1. Viewpack

60 WALSH ST - NEW GYM REC BARN - OB SUB 08 25 2020.PDF
32 WEST CHESTER ST - NEW DWELLING - OB SUB 08 25 2020.PDF
5 N LIBERTY ST - DOOR REPLACEMENT - OB SUB 08 25 2020.PDF
32 N LIBERTY ST - NEW ADDITION - OB SUB 08 25 2020.PDF
32 N LIBERTY ST - LETTER FROM OWNER 08 25 2020.PDF

OLD BUSINESS CHECKLIST

PREVIOUS

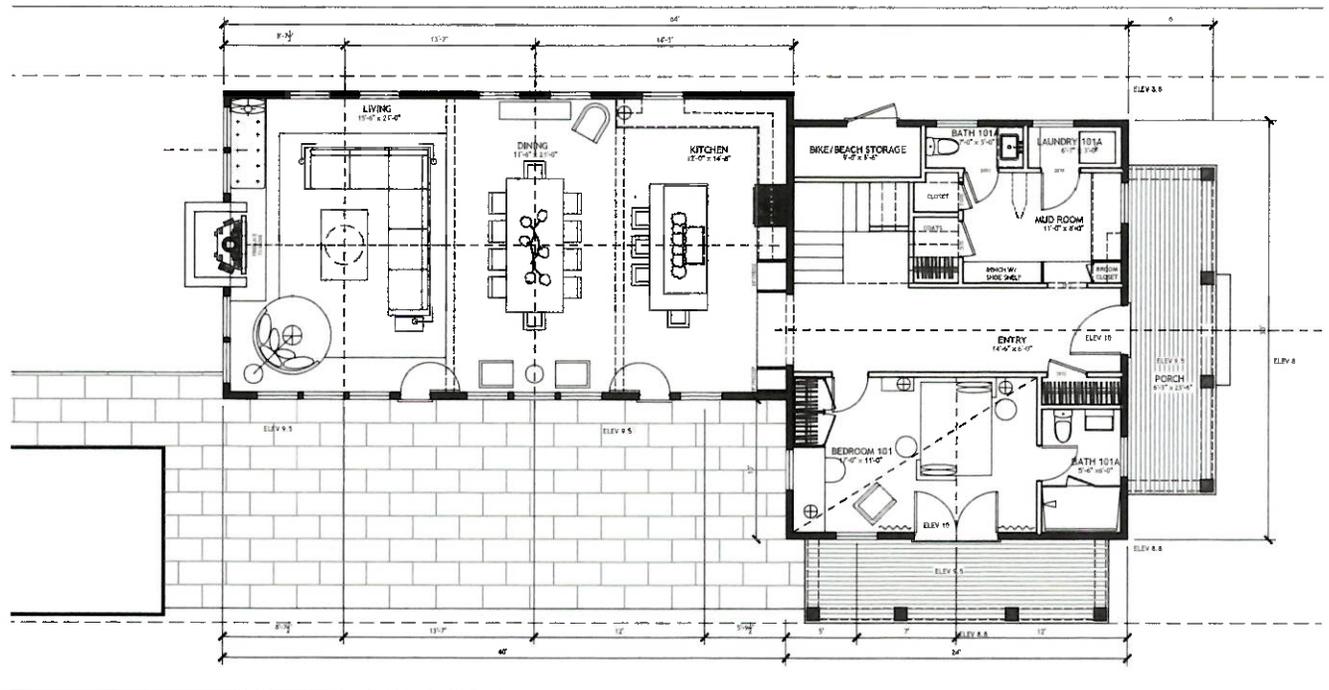
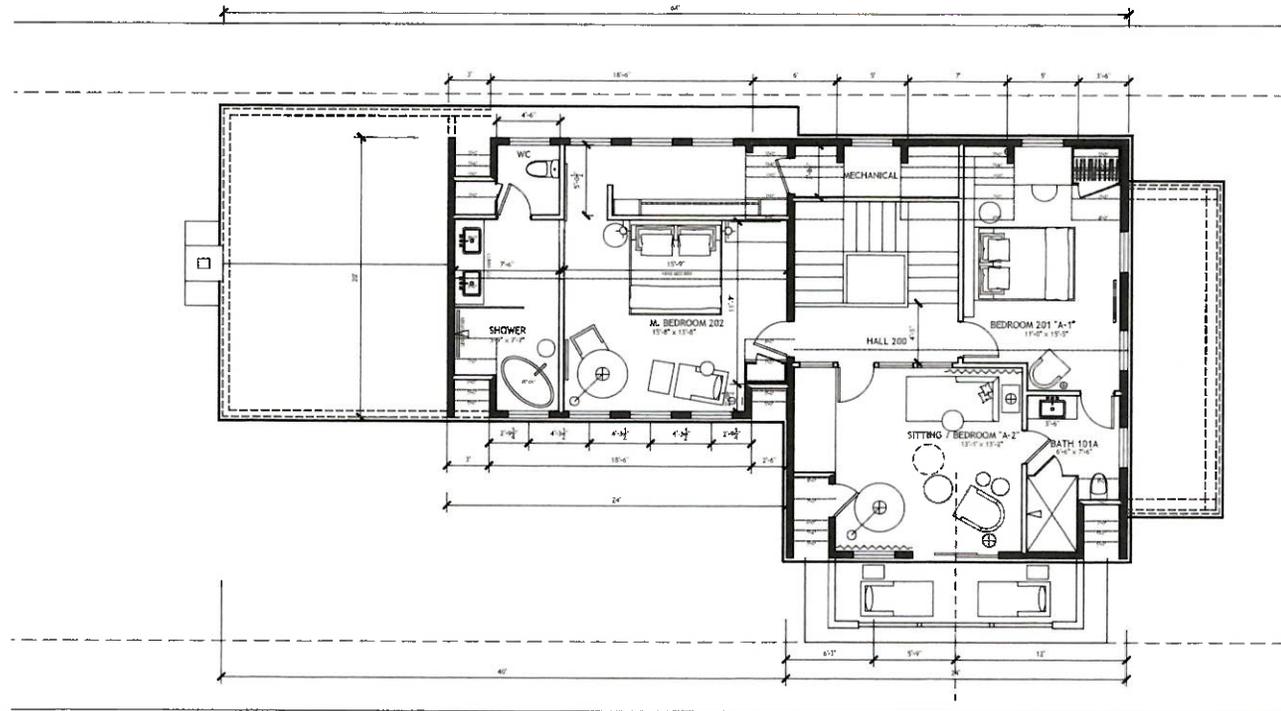
Oliver – Agrees that the front door be a 2-panel with 6 lights. Agrees about adding corner boards on the front mass and rear. Her main concern is visibility of the west and south elevations; there is a lot of fenestration on the south. The railing should be simple: all balusters or shingled. South elevation needs some sort of mitigation because it will be visible across the pond; the French doors should be more traditional with kick panels. The massing is fine.
 Motion **Motion to Hold for minor revisions. (Welch)**
 Roll-call Vote Carried unanimously//Oliver, Welch, and Coombs-aye Certificate #

SOUTH ELEVATION

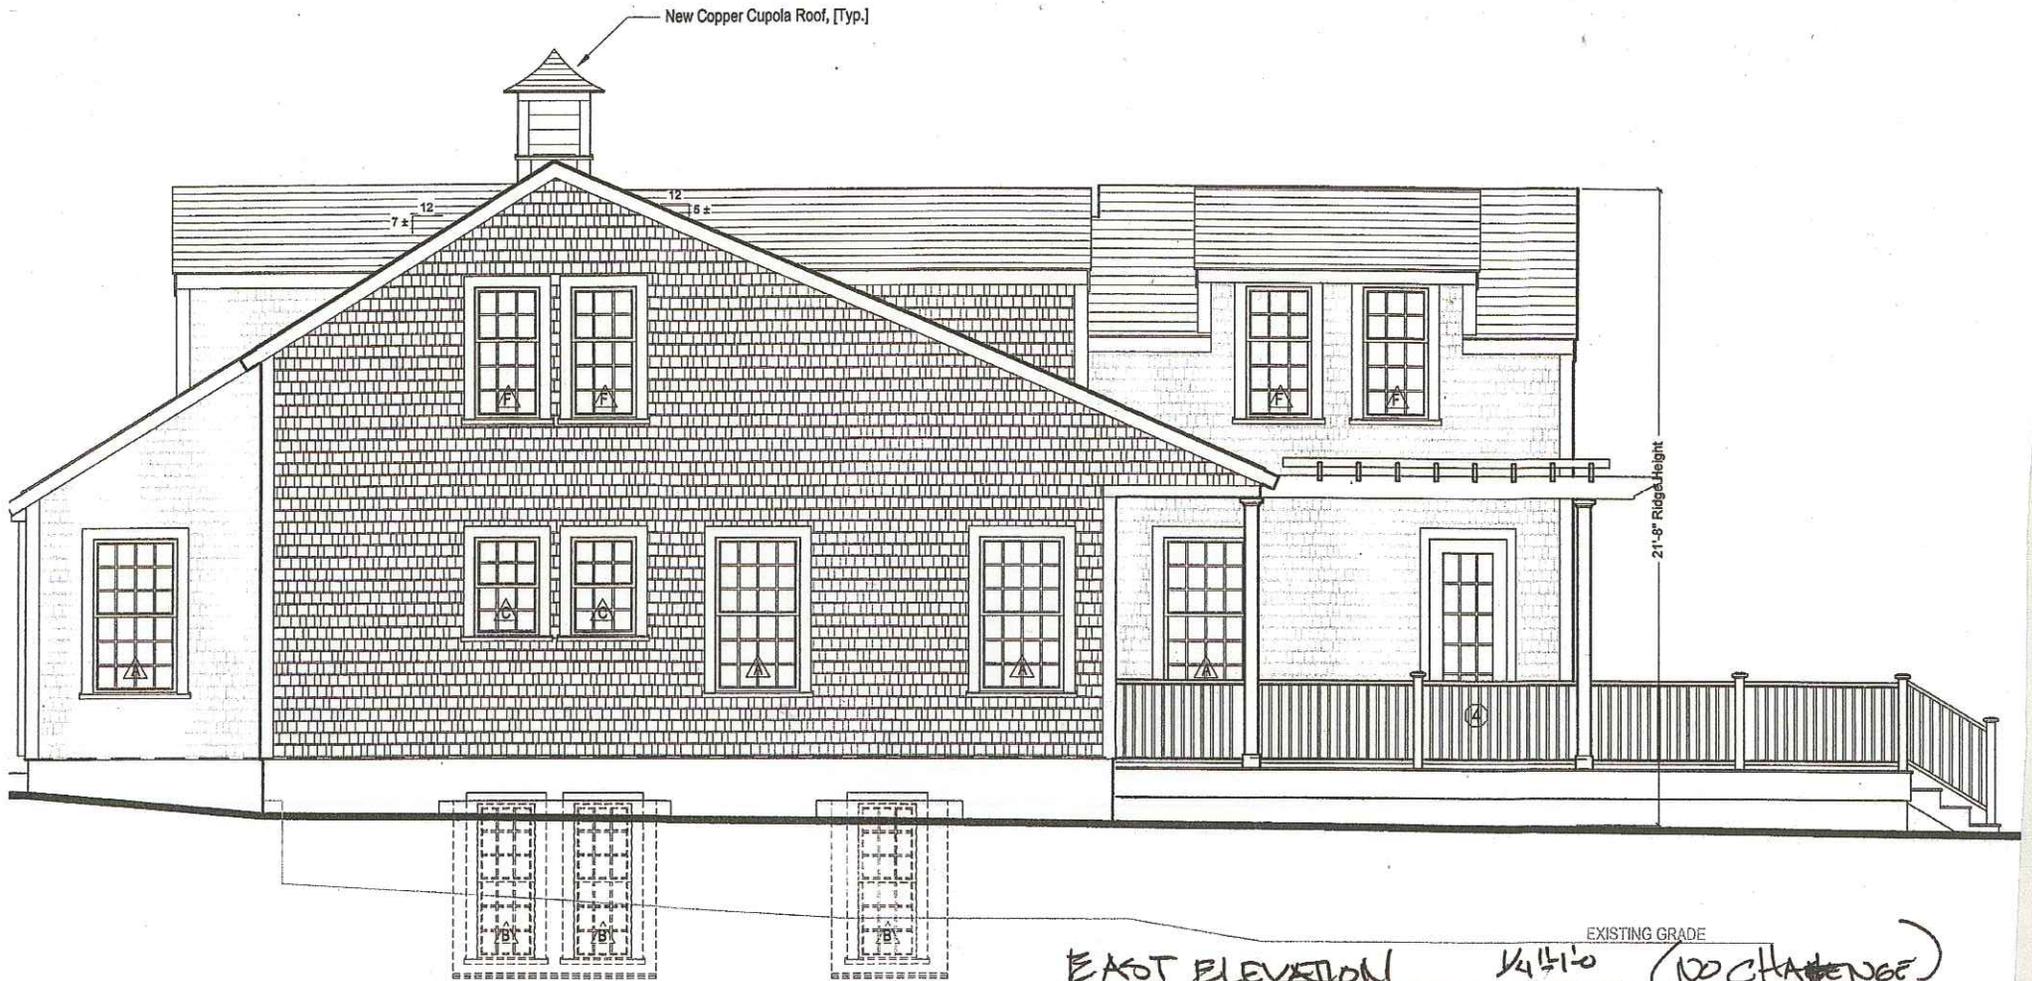
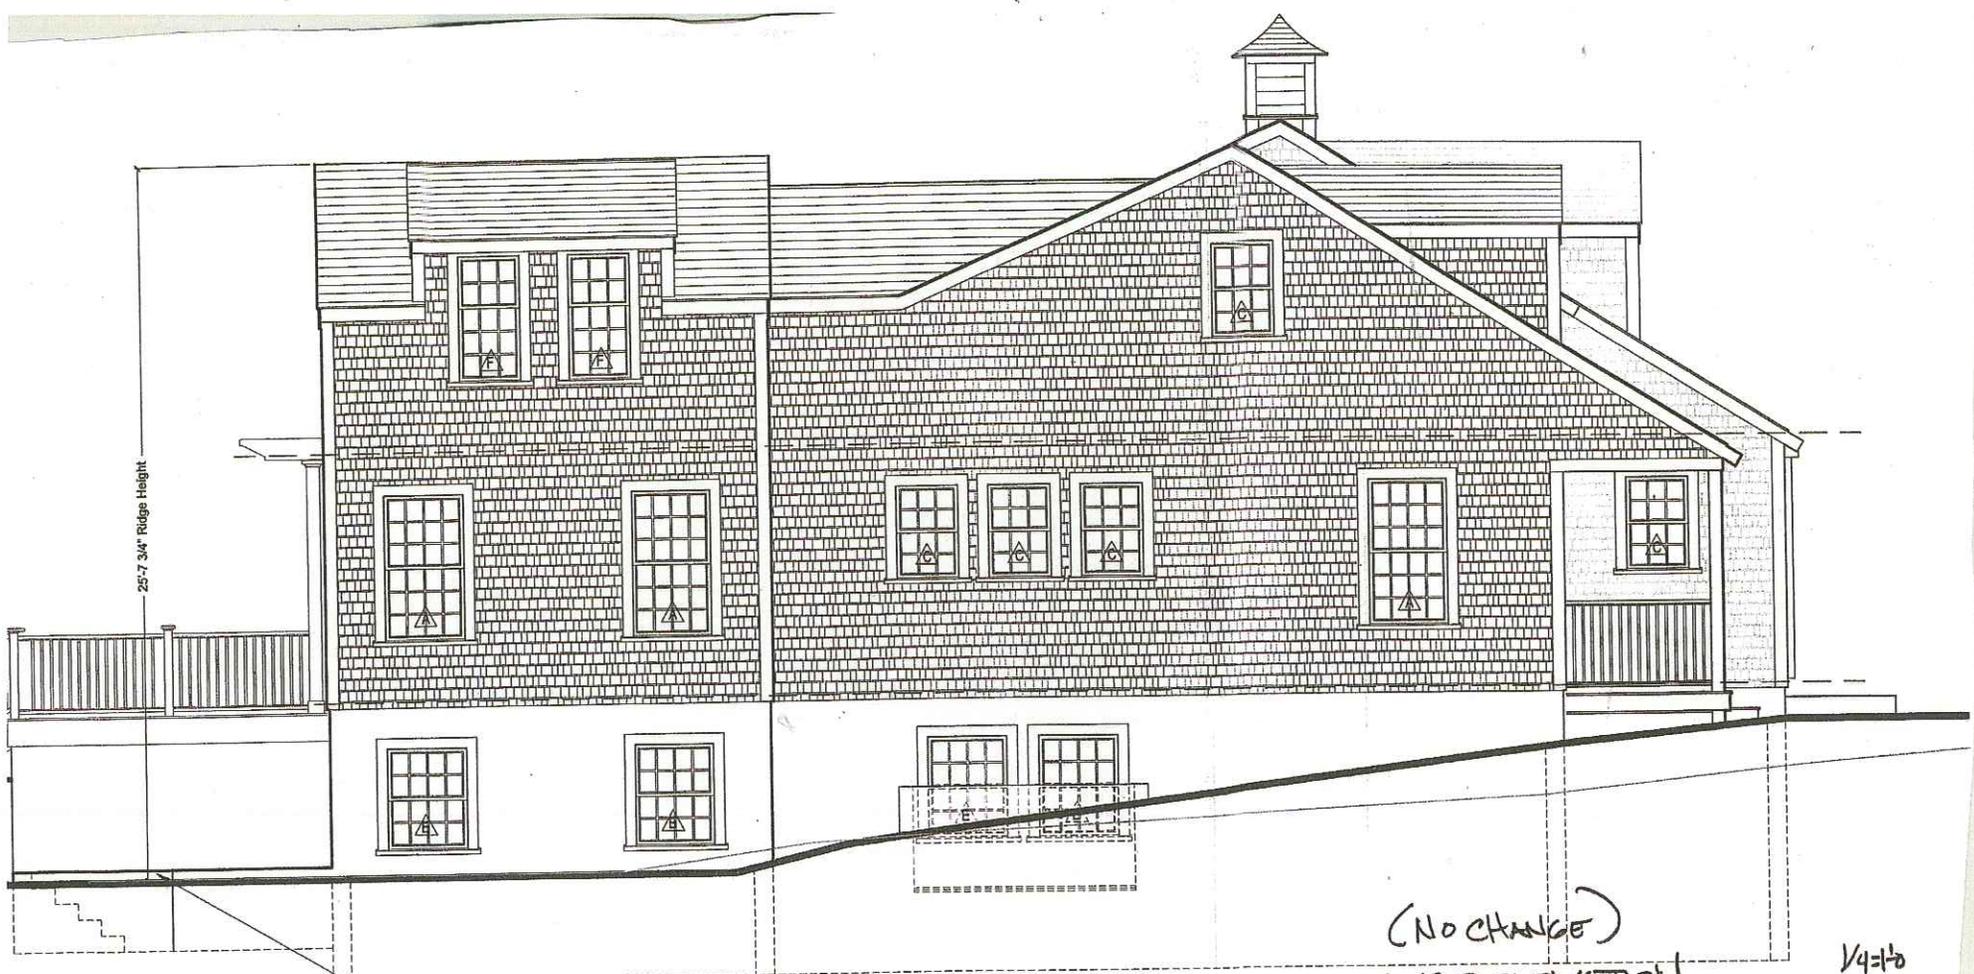
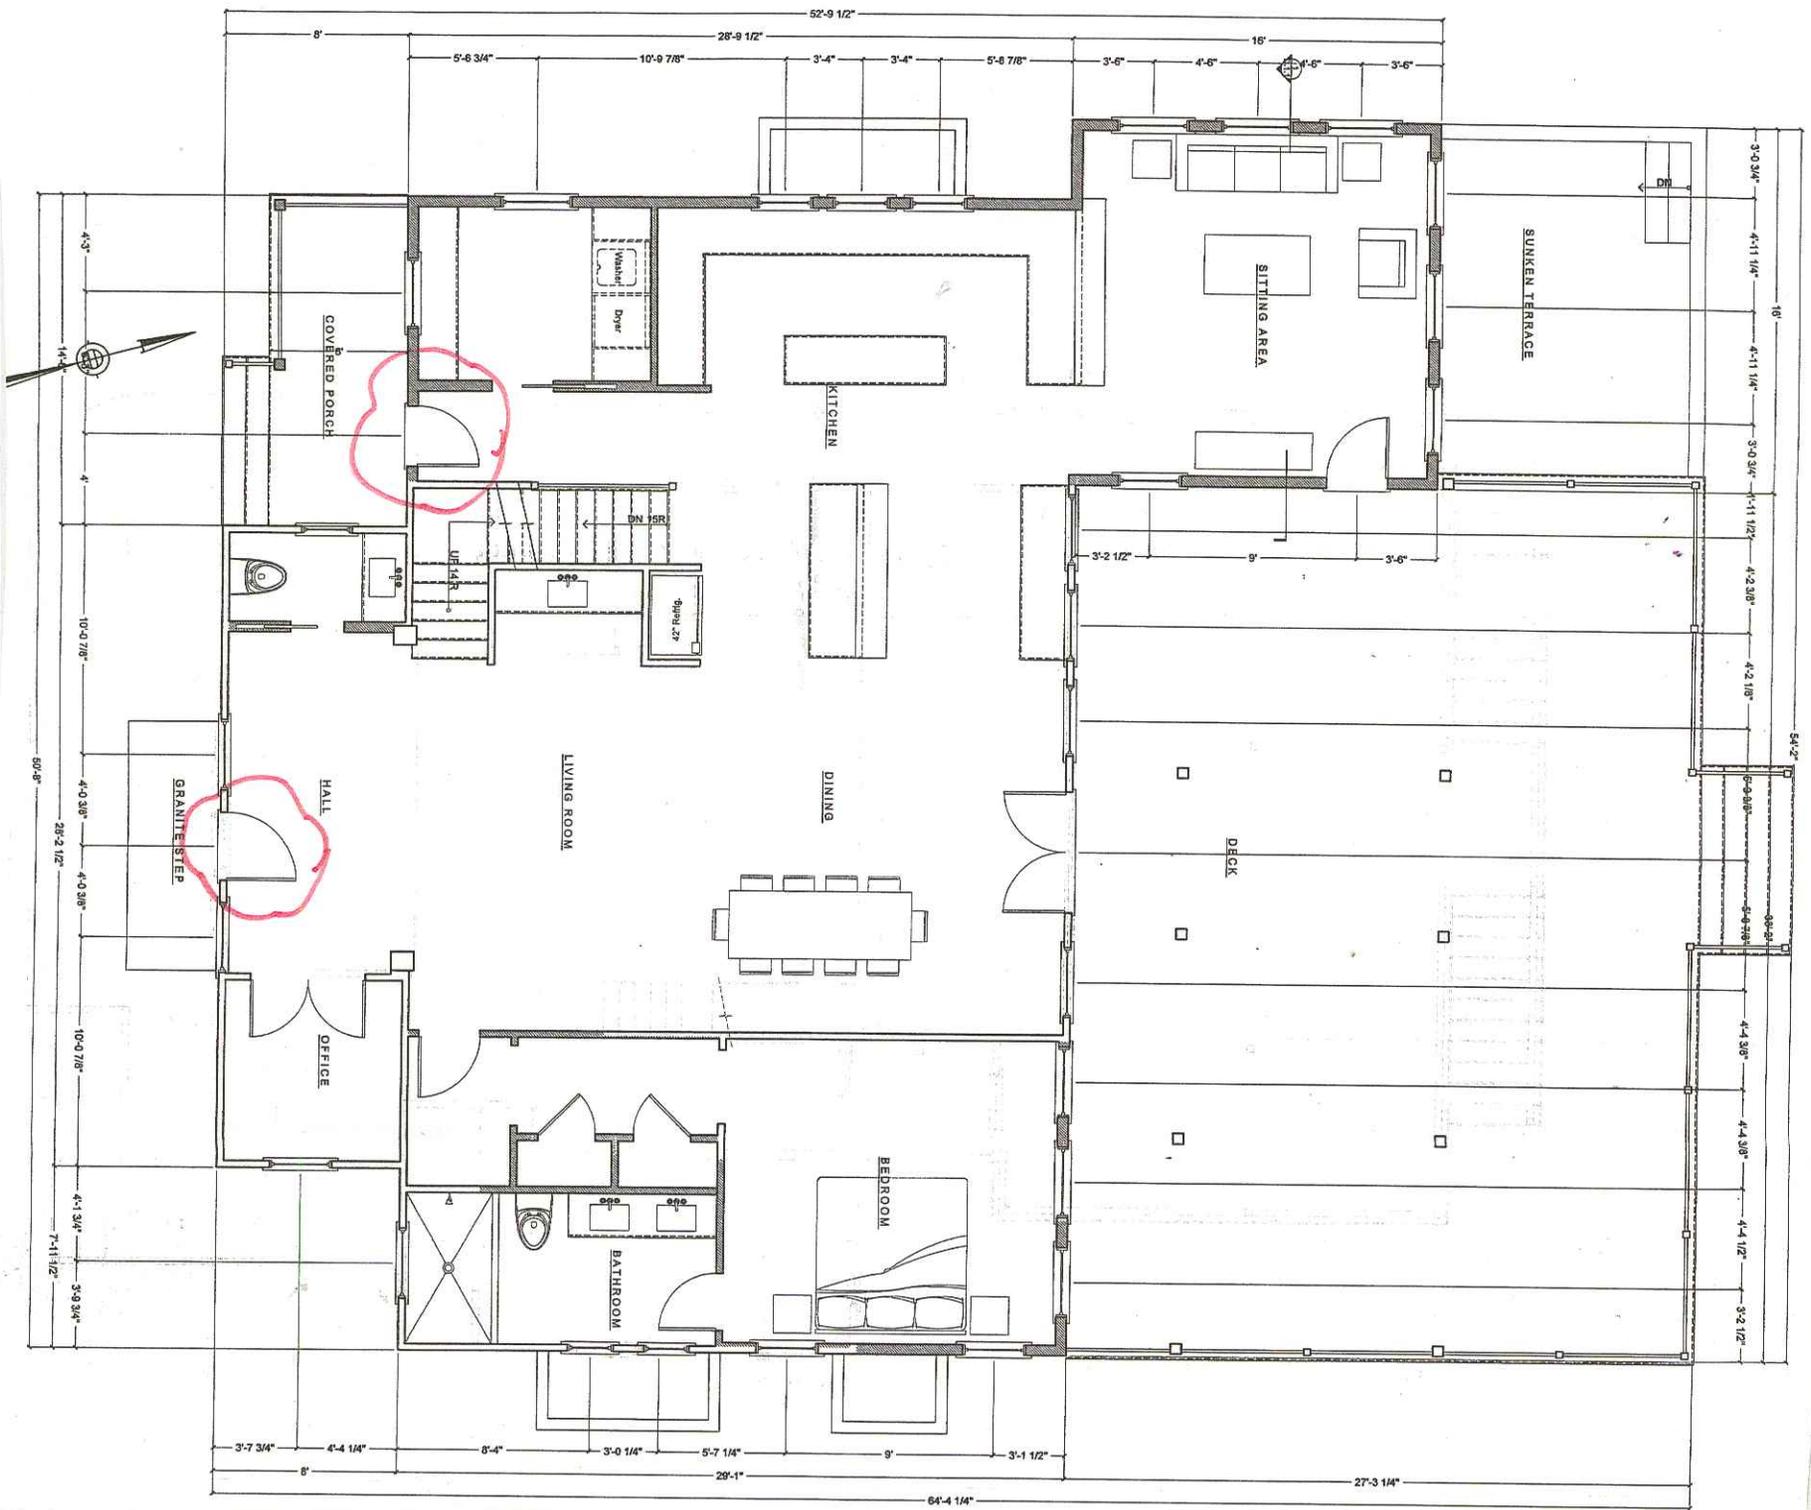
Voting Pohl, Coombs, Camp, Oliver, Welch
 Alternates None
 Recused None
 Documentation Architectural elevation plans, site plan, photos, historic documentation, and advisory comments.
 Representing Steve Theroux, Nantucket Architectural Group
 Public None
 Concerns (7:29) **Backus** – Circa 1930; theater 1940 through 1960s; recommends approval. Read HSAB comments.
Theroux – Presented project; owner wants the Dutch door and front door to match
Oliver – The 9-light Dutch door is okay, but she doesn't support a 9-light front door.
Camp – She supports this.
Coombs – A 9-light Dutch door would have to be the same width as the front door.
Welch – A Dutch door on the left with current proportions is way out of whack; it won't look like the "new spec" drawing. It needs to be wider or it'll look strange. Suggested, a different configuration than 9 lights in both doors; a 12-light would pick up the existing fenestration.

Motion **Motion to Hold for revisions with actual drawings of the size and configuration both doors. (Camp)**
 Roll-call Vote Carried 5-0//Coombs, Welch, Oliver, Camp, and Pohl-aye Certificate #

PROPOSED 9 LIGHT DOOR
 3'-0" x 7'-6 1/2" BOTH DOORS
 SAME SIZE

PROPOSED 12 LIGHT DOOR
3'-0" x 7'-6 1/2" BOTH DOORS
SAME SIZE
